# Danescourt Community Association

**Planning Application 20/00187/MJR  
Residential Development for 45 Dwellings - Land at De Braose Close,  
Danescourt, Cardiff**

## **OBJECTION**

**Fig.1 The woodland in Summer. Note the absence of littering & ground disturbance**

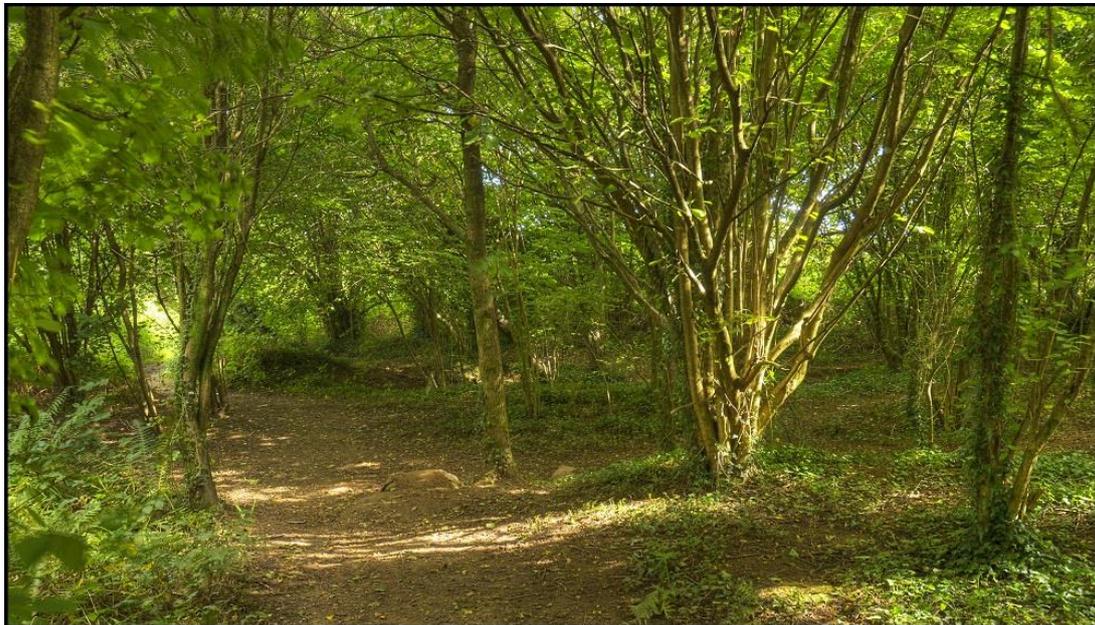
5. The woodland is described as having little ecological value within the Green Infrastructure Statement and several illustrations included within the Applicant's submitted documents display it as being not particularly attractive. The submitted photographs have all been taken during the autumn or perhaps winter however when the deciduous woodland has abandoned all its greenery and hardly looks at its best. A photograph taken in summer which is attached hereto shows how really attractive this woodland actually is. (Fig.1)

7. The Design and Access Statement states the site is *"subject to regular public use, with littering and ground disturbance widespread."* Reference to Fig.1 also shows this description to be wrong.

**Fig.3 Natural Resources Wales Flood Risk Map**

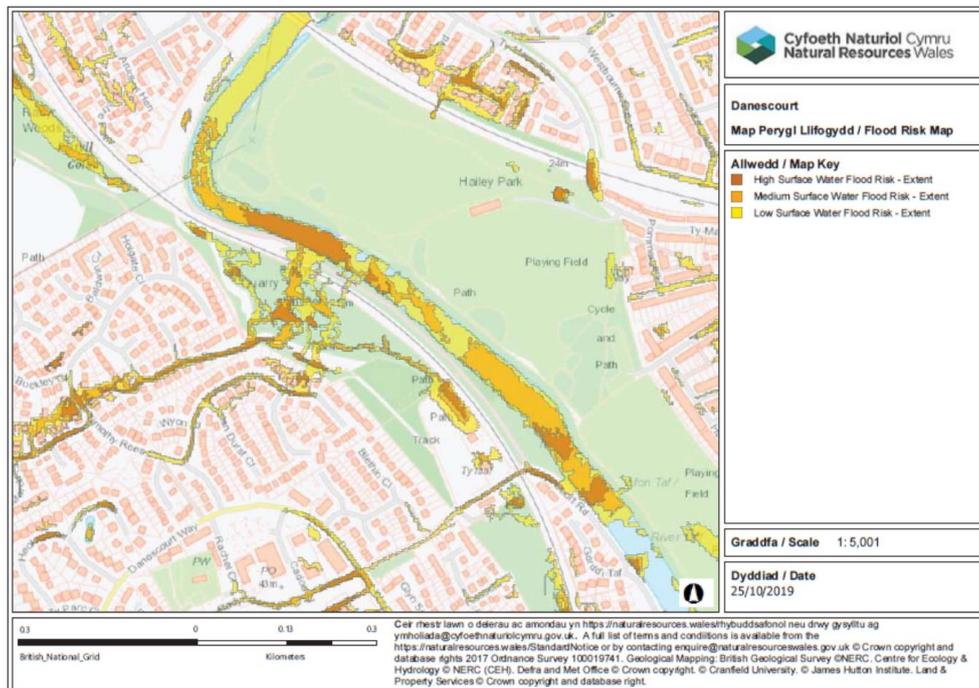
26. The NRW Development plan shows the flood risk areas with the site to be at the end of a surface water flow path corridor (Fig.3). Development of the site will alter the route of this flow path corridor and could lead to additional flooding, either within the site or in areas adjacent to it. This situation has not been considered within the submitted drainage design.

27. The proposed location of the foul water pumping station is coincident with the route of the surface water flow corridor. This pumping station is consequently also at risk of flooding, which when it happened could cause the foul drainage system for the site to collapse.
